Permit Modification Request

Amended Closure Plan

Waste Isolation Pilot Plant Carlsbad, New Mexico

Subject: Permit Modification Request: Closure Plan Amendment

Figure I-2 WIPP Panel Closure Schedule

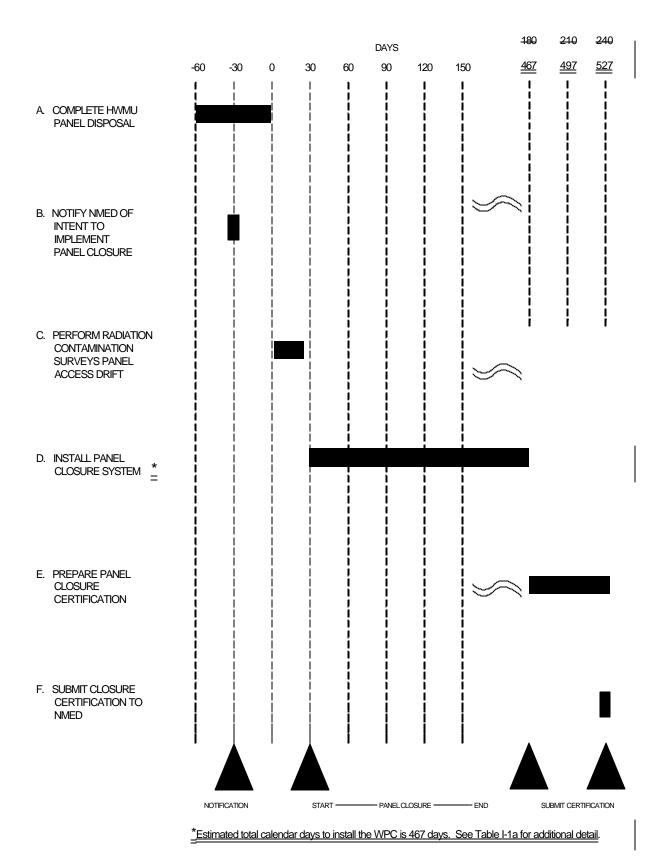
Reference	Explanation for Change
Permit Attachment I, Table I-1a and Figure I-2	A new schedule Table I-1a detailing the number of days for each panel closure activity has been inserted and Figure 1-2 is updated to reflect the schedule for WPC installation.
Permit Attachment I, Figure I-4	This Figure is being replaced with Figure 2-1 from the design report.
Attachment I1, Attachment I1 Appendix G, and Attachment I1 Appendix H	The Design Report for the Revised Panel Closure System at the Waste Isolation Pilot Plant, Rev 1, October 2002 (which includes WPC technical specifications and design drawings) is proposed for inclusion as Attachment I1. This will result in deletion of the current Attachment I1, Attachment I1 Appendix G and Attachment I1 Appendix H from the Permit, and the information in those attachments will be found in the revised Attachment I1.
Attachment M2, Section M2-2b	Added reference to the closure plan for pertinent panel closure information and eliminated information that is associated with the closure plan and Module IV.

The anticipated schedule for the closure of each of the underground HWDUs known as Panels 1 through 8 is shown in Figure I-2 and Table I-1a. This schedule assumes there will be little contamination within the exhaust drift of the panel. The following assumptions are made in estimating the time that closure will be initiated at each underground HWDU: waste operations are assumed to begin in July 1998 for planning purposes; throughput for CH waste is 784 drums per week (7 pallets per day, 4 days per week, 28 drums per pallet); and the capacity of a panel is 81,000 drums. Under these assumptions, a minimum of 104 weeks is needed to emplace a panel of the waste. Allowing a 25 percent contingency margin for maintenance delays and time to transition from one room to another, it is estimated that a panel will be filled 2.5 years after emplacement is initiated. The panel closure schedule reflects the anticipated closure dates for the underground HWDUs based on throughput estimates as of August 1, 2002. These dates are reflected in Table I-1. This means that underground HWDUs will be ready for closure according to the schedule in Table I-1. These dates are estimates for planning and permitting purposes. Actual dates may vary depending on the availability of waste from the generator sites. Waste availability at maximum throughput is not anticipated immediately as assumed here. Panel 1 closure will follow the schedule presented in Table I-1, and Table I-1a.

Figure I-4
Design of a Panel Closure System

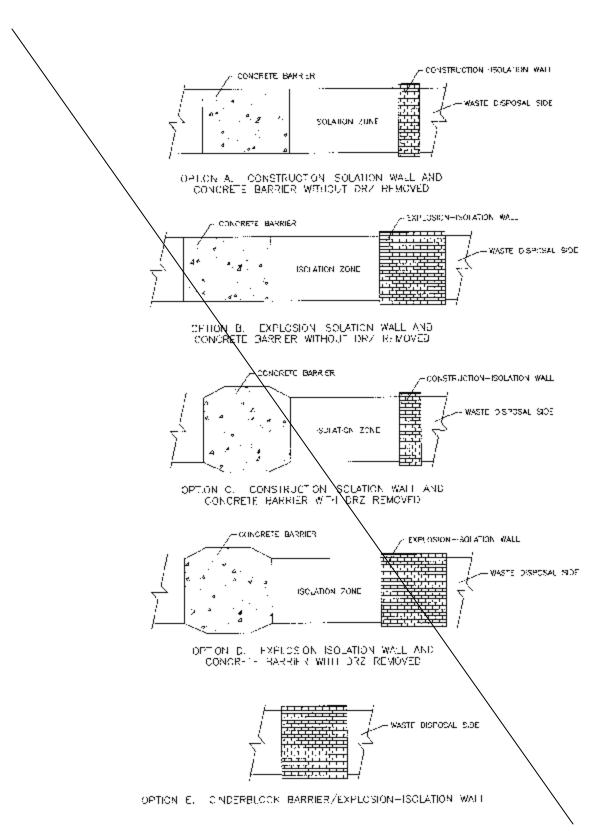
This modification request proposes to amend the closure plan by revising the Panel Closure System (**PCS**). The approved PCS, known as "Option D," requires emplacing a 12-foot explosion isolation wall and emplacement of a 26-foot monolith composed of Salado Mass Concrete (**SMC**). The new PCS, referred to as the WIPP Panel Closure (**WPC**), consists of a substantial 30-foot mortared concrete block explosion isolation wall and emplacement of 100 feet of run of mine salt as backfill. The term "run of mine salt" refers to salt obtained from routine mining activities in the WIPP underground and used as backfill. The major components of each system are summarized in the following table:

Figures I-4 and I-5 show a diagram of the panel closure design and installation envelopes. Permit Attachment I1 provides the detailed design and the design analysis for the panel closure system. Although the permit application proposed several panel closure design options, depending on the gas generated by wastes and the age of the mined openings, the NMED and EPA determined that only the most robust design option (D) would be approved. This The decision to select a design option does not prevent the Permittees from continuing to collect data on the behavior of the wastes and mined openings, or proposing a modification to the Closure Plan in the future, using the available data to support a request for reconsideration of a new one or more of the original design options. If a design different from Option D as defined in Permit Attachment I1 that defined in Permit Attachment I1 is proposed, the appropriate permit modification will be sought.

This modification primarily entails replacing the Option D specifications and drawings with the WPC specifications and drawings. The WIPP HWFP was the standard used to determine the adequacy of the WPC. The Permittees have determined that the WPC meets the terms of the HWFP and that it is at least as protective as Option D in satisfying the environmental and closure performance standards. The evaluation of the WPC and its level of protectiveness is provided in the attached *Design Report for a Revised Panel Closure System at the Waste Isolation Pilot Plant, Rev. 1, October, 2002.*
